| JAN 3 0 7007 | t and Trademark Office | UNITED STATES DEPAR United States Patent and Address: COMMISSIONER F P.O. Box 1450 Alexandria, Virginia 22: www.uspto.gov | Trademark Office OR PATENTS |
|--|------------------------|--|--------------------------------|
| 10/615,134 07/08/2003 | Waldemar Brinkis | 502901-155 | 8115 |

| | | Applicati | on No. | Applicant(s) | |
|---|---|--|--|---|---|
| | Office Action Summary | Examine | | Art Unit | |

DETAILED ACTION

CHOSEN-DRAWING: Dwg.1/1

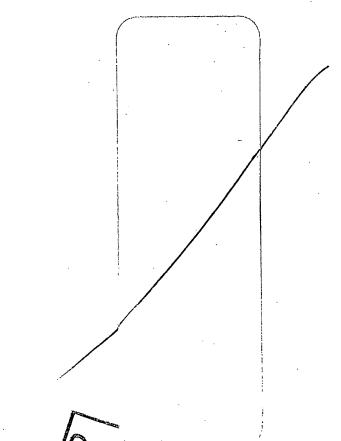
Regarding claim 1, Mattmann shows an electronics unit, comprising: a low multi-point metallic mount [1];

an insulating layer [2] arranged on said mount;

a conductor track system [4,5,6,7, which is a thick film type conductor, see English abstract] on said insulating layer [2]; and

electronic power components [9, it is well known to use several power devices in a single circuit or system, see elements 66 of Figure 14 of Morita et al. (Us 2002/0074651)] arranged on said conductor track system [4,5,6,7]. Mattmann does not show an insulating layer comprises a sintered electrically insulating polymer layer and also does not specify the conductor track system is comprised of a sintered glass frit with a noble metal filling. Asai shows (e.g. Figures 5-8) an insulating layer comprises a sintered [it is well known in the art that epoxies are cured by the application of heat, see line 7 of paragraph 0030 of Sakamoto et al. (US 2002/0020554)] electrically insulating polymer layer [1, which is used to connect conductor tracks 3' to metal base 8]. Asai teaches the benefits of having an insulating layer which is comprised of a sintered electrically insulating polymer layer as a material which can be used to permit high heat conductivity [column 2: line 60 to column 3: line 4]. It would have been obvious to one of ordinary skill in the art at the time the invention was made to include the insulating layer comprising a sintered electrically insulating polymer layer arranged on said mount in the invention of Mattman as suggested by Asai because the insulating layer can be used to permit high heat conductivity. Liederbach shows an electronic system which has a conductor track system [4,6,8,10,12,14] is comprised of a sintered glass frit with a noble metal filling [column 3: lines 8-31]. Liederbach teaches the benefit of using a conductor track system is comprised of a sintered glass frit with a noble metal filling to

Regarding claim 6, Mattmann in view of Asai and Liederbach show the electronics unit of claim 1. In addition, Mattmann shows wherein said mount [1] comprises cooling ribs [protrusions on bottom surface].

Regarding claim 8, Mattmann in view of Asai and Liederbach show the electronics unit of claim 1. In addition, Mattmann shows comprising at least one of electrical and electronic components [9] arranged on the conductor track system [between 6 and 7].

Regarding claim 9, Mattmann in view of Asai and Liederbach show the electronics unit of claim 8. In addition, Mattmann shows wherein said power components [3] and said at least one of electrical and electronic components [9] are conductively connected to the conductor track system by bonding [both are bonded to conductor tracks 4,6,7].
